Shippensburg University

SUPPLEMENT 1 Electrical Coordination Study

Professional:
Entech Engineering, Inc.
4 South Fourth Street
P.O. Box 32
Reading, PA 19603
Telephone: 610-373-6667
Fax: 610-373-7537
www.entecheng.com
Entech Project #: 2184.22

August 24, 2004

TCC Name: 1201
Rev. 0.0
Date: March 11, 2004

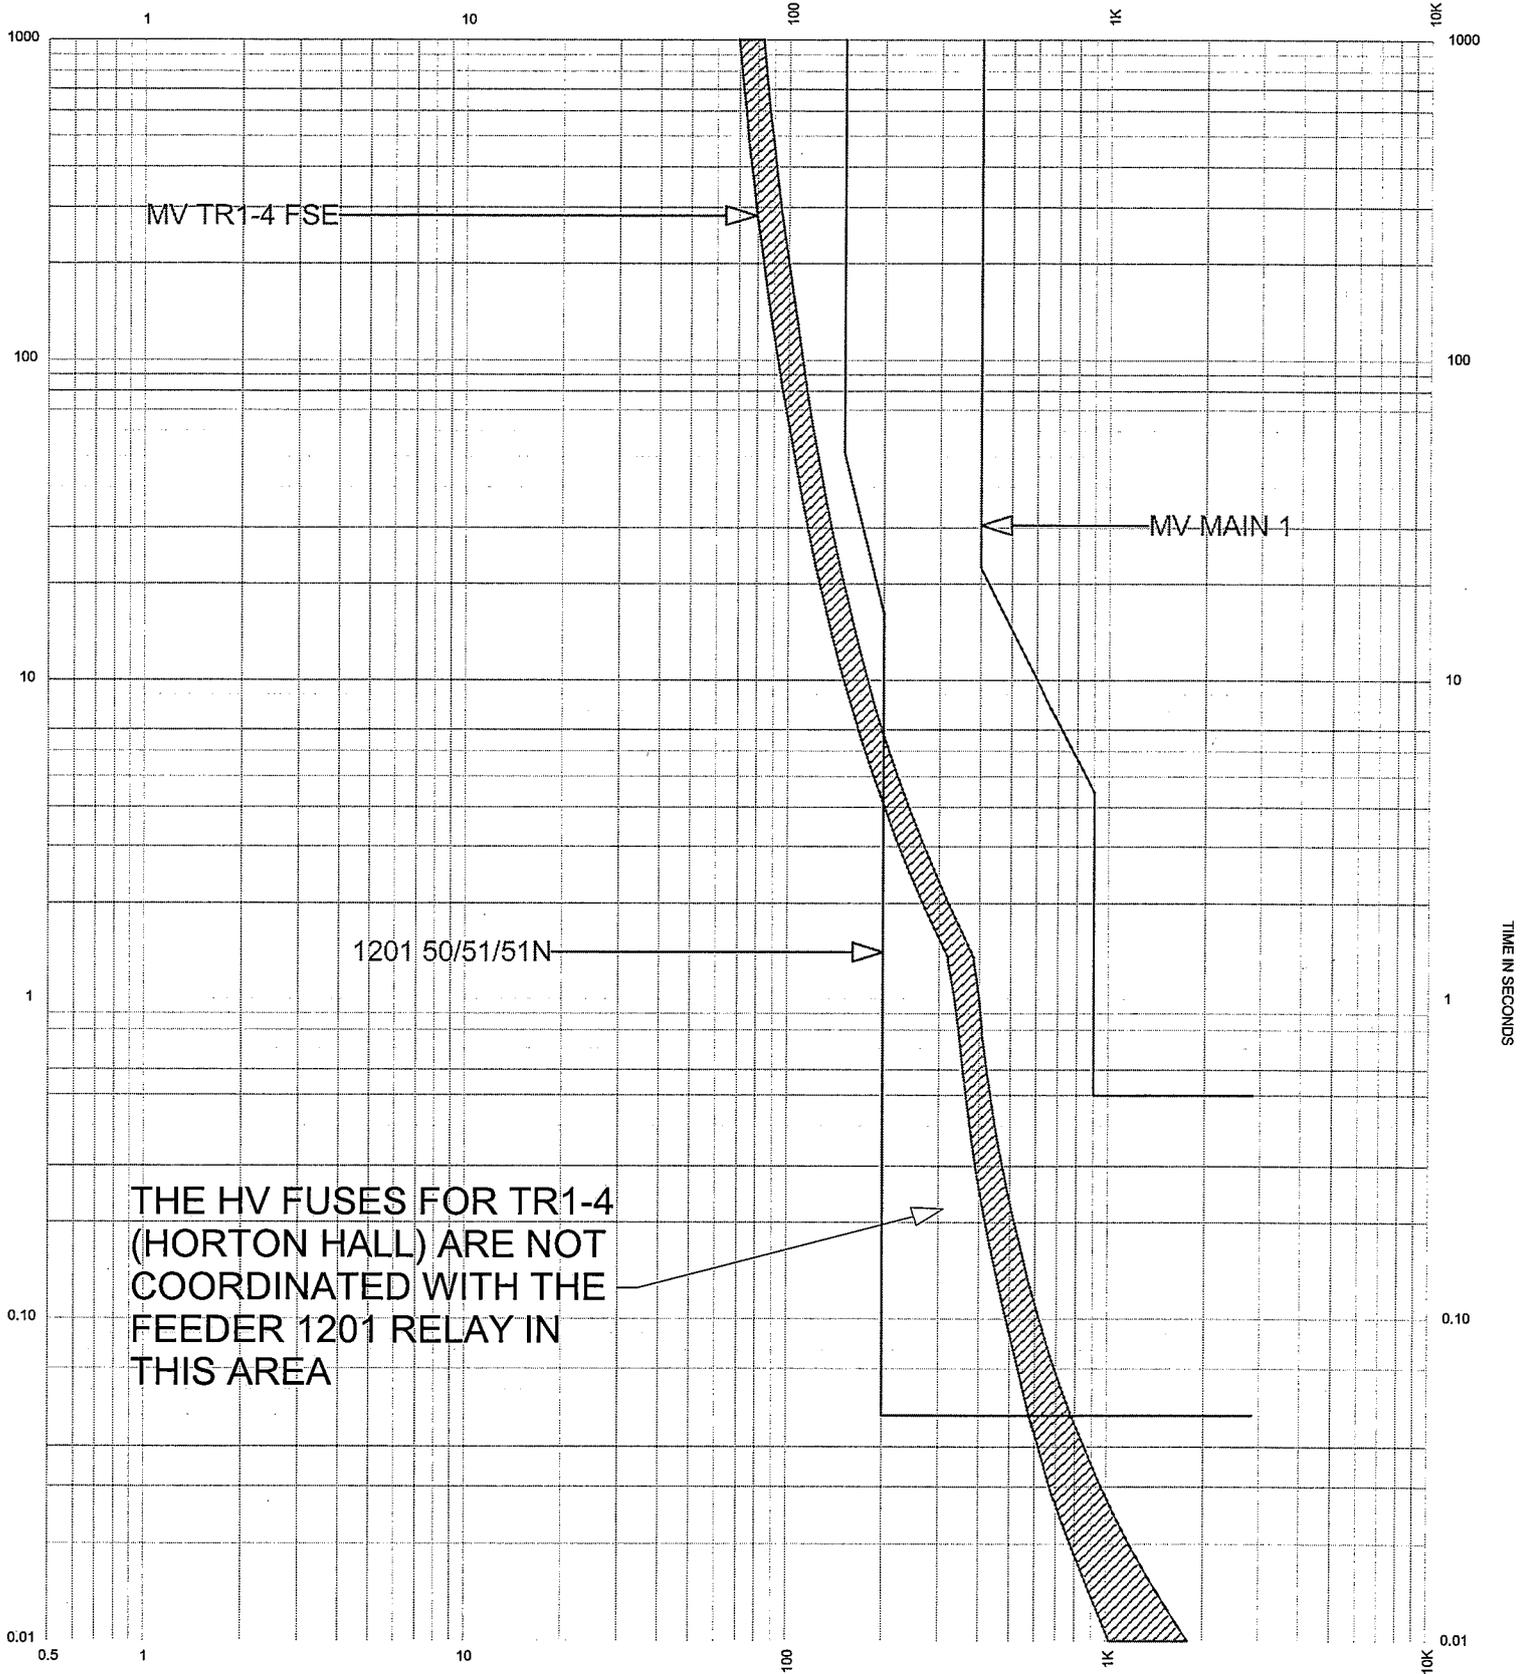
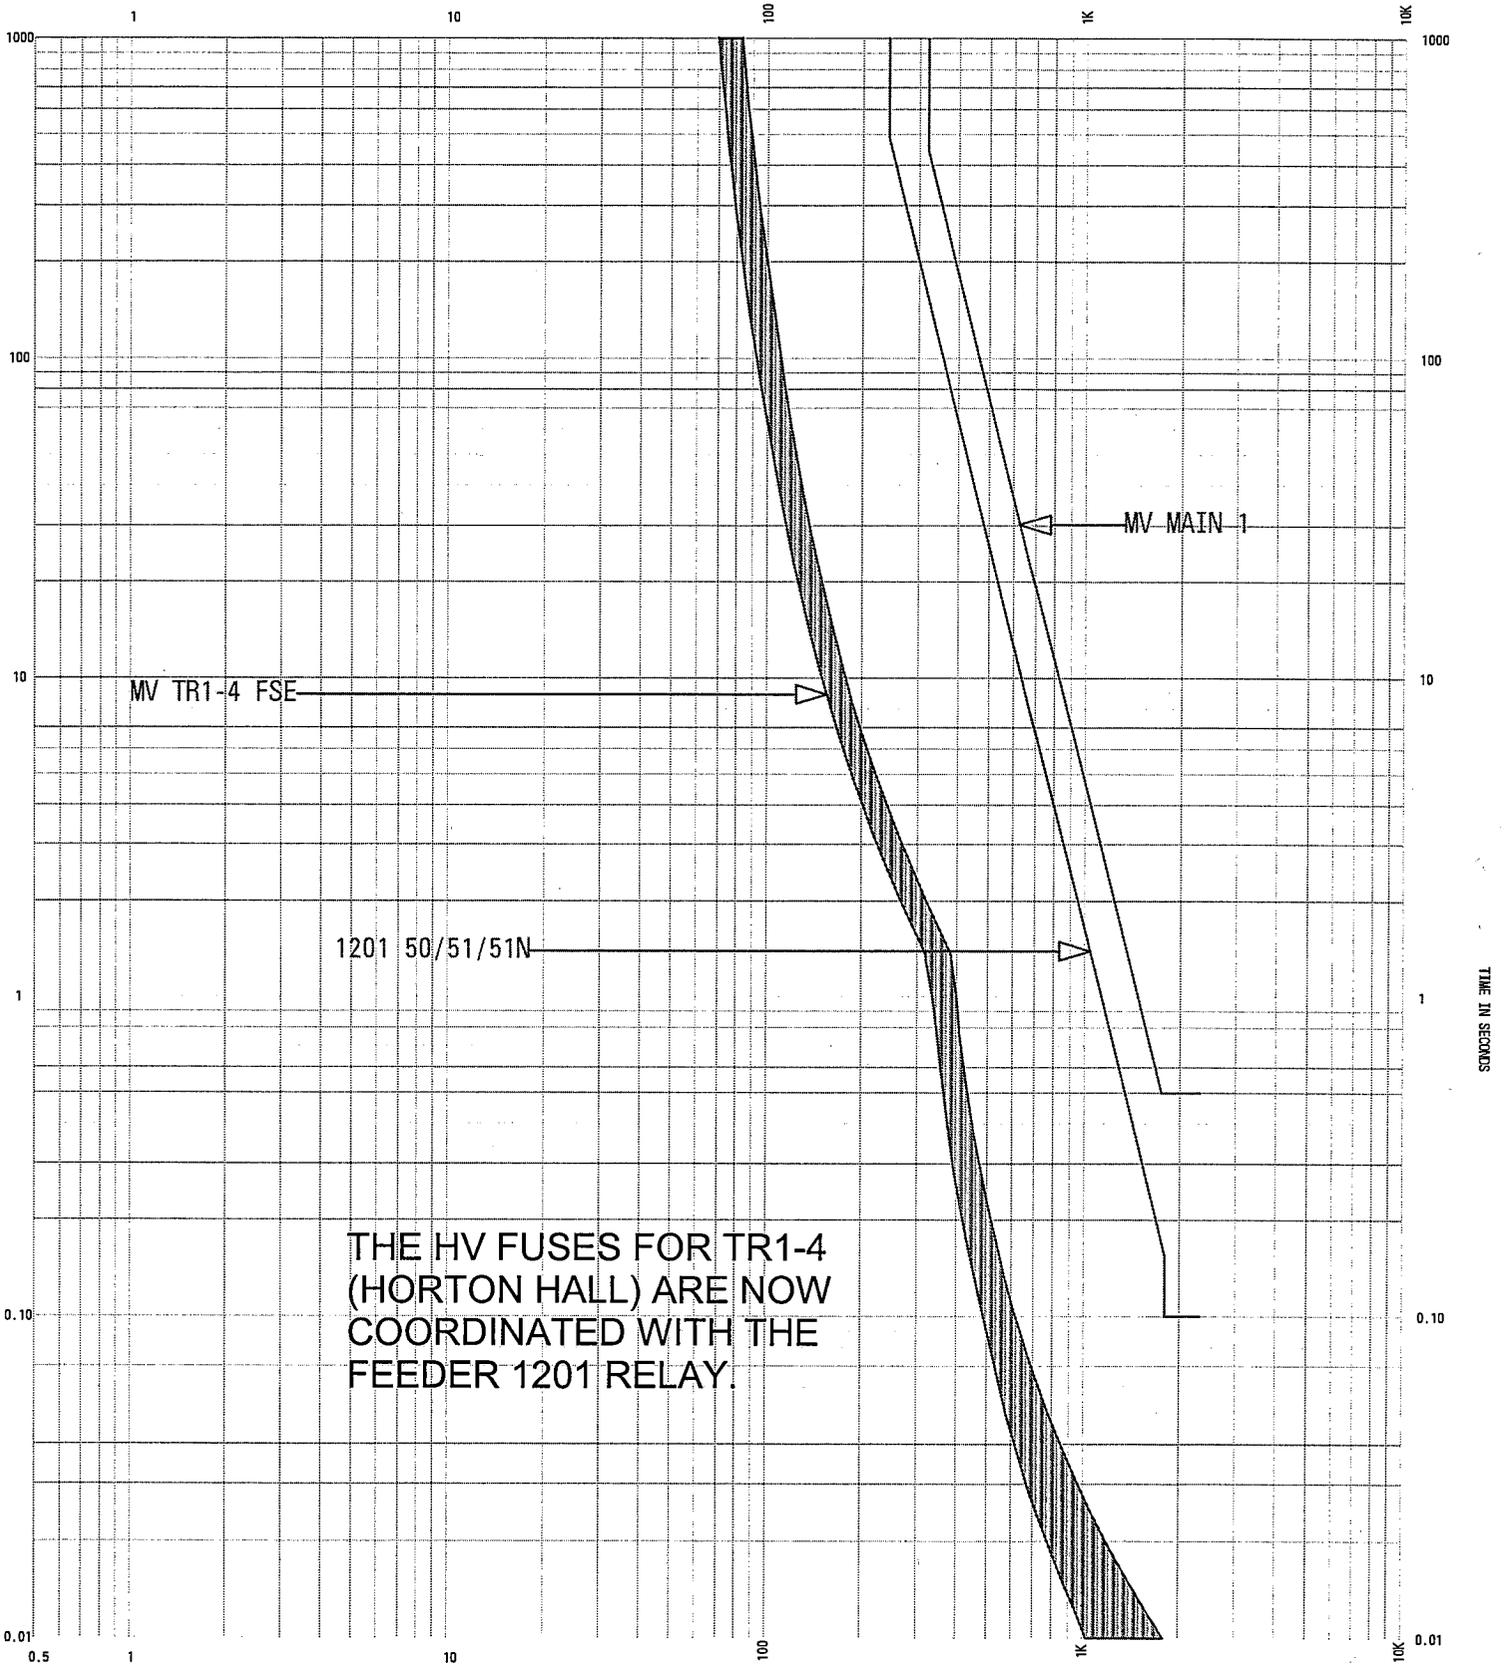
1. The feeder 1201 circuit breaker relay is not coordinated with the high voltage fuses for Horton Hall (TR1-4) in the short time and instantaneous area.
2. The feeder 1202 circuit breaker relay is not coordinated with the high voltage fuses for Old Main (TR2-9) in the short time and instantaneous areas.

THE HV FUSES FOR TR1-4 (HORTON HALL) ARE NOT COORDINATED WITH THE FEEDER 1201 RELAY IN THIS AREA

RECOMMENDED RELAY SETTINGS*						
Setting	Main #1	Main #2	1201	1202	1203	1204
Curve	I4T	I4T	I4T	I4T	I4T	I4T
LTPU	0.8	0.8	1.2	1.2	1.2	1.2
LTD	2.25	2.25	12.5	12.5	12.5	12.5
STPU	4.5	4.5	9.0	9.0	9.0	9.0
STD	0.5	0.5	0.1	0.1	0.1	0.1
INST	25	25	—	—	—	—

THE HV FUSES FOR TR1-4
(HORTON HALL) ARE NOW
COORDINATED WITH THE
FEEDER 1201 RELAY.

TCC Name: 1202
Rev. 0.0
Date: March 11, 2004

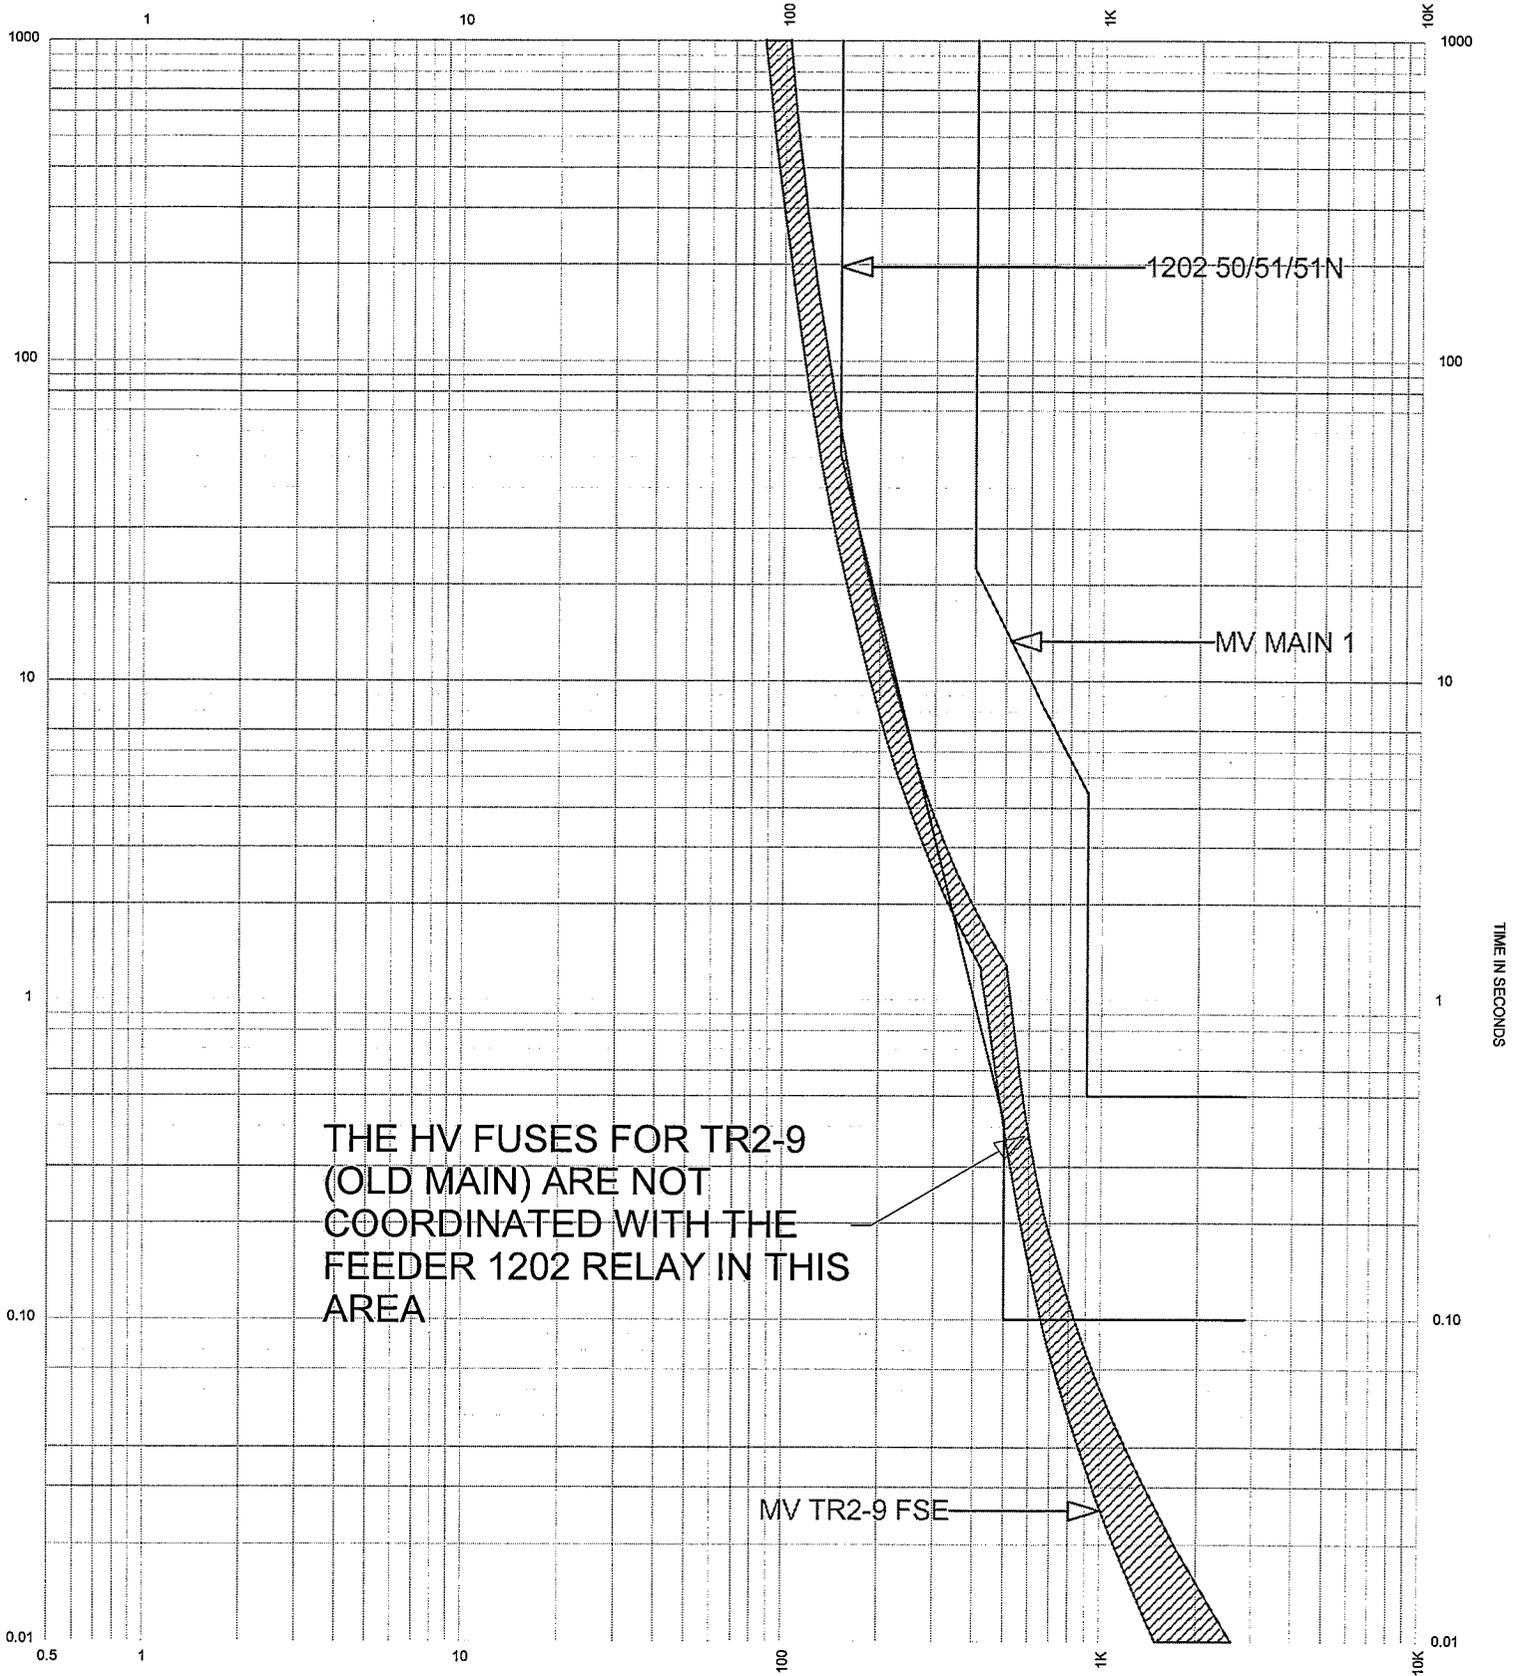
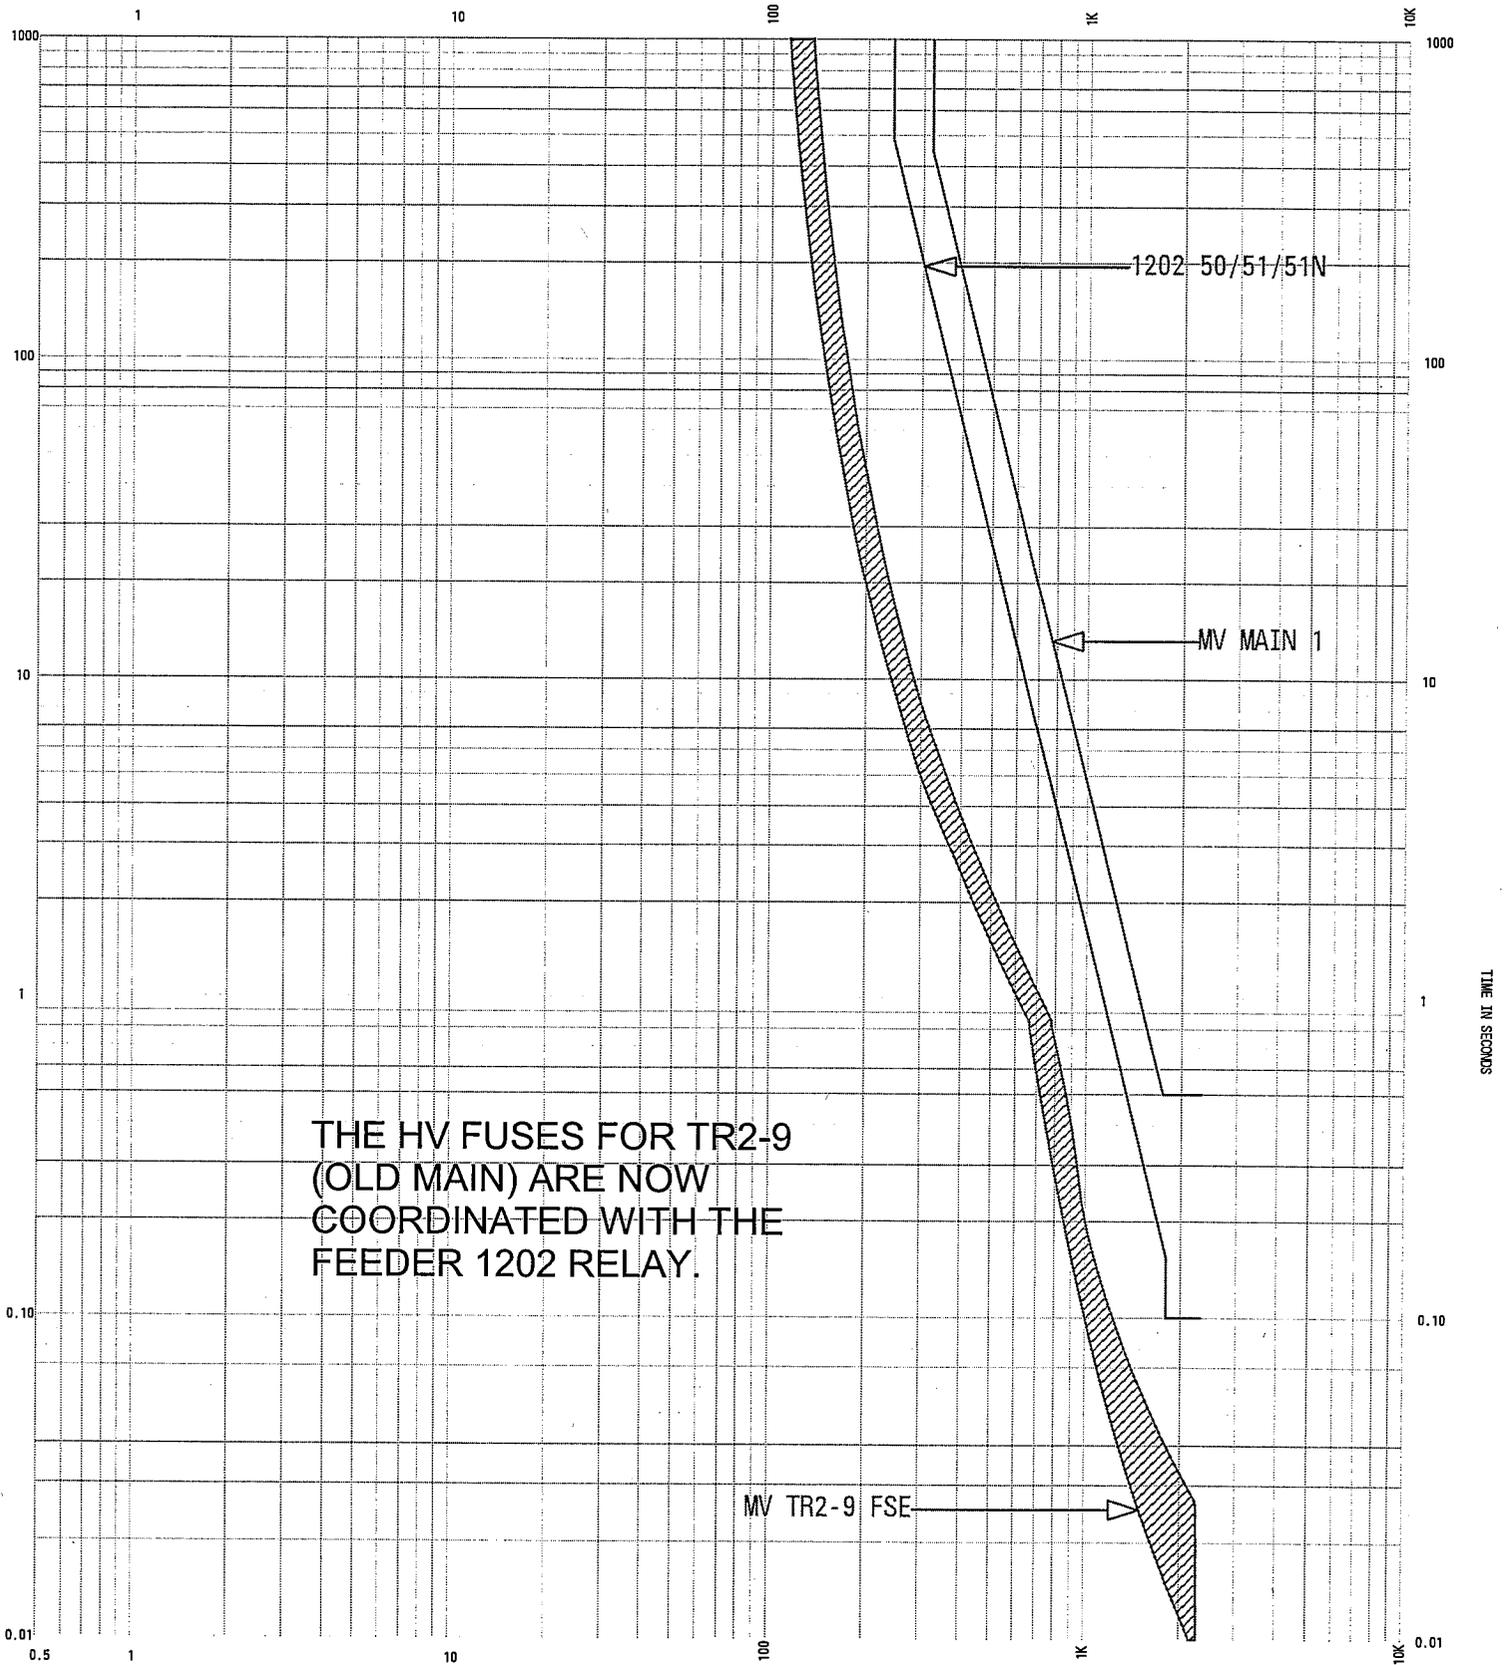
THE HV FUSES FOR TR2-9
(OLD MAIN) ARE NOT
COORDINATED WITH THE
FEEDER 1202 RELAY IN THIS
AREA

THE HV FUSES FOR TR2-9
(OLD MAIN) ARE NOW
COORDINATED WITH THE
FEEDER 1202 RELAY.
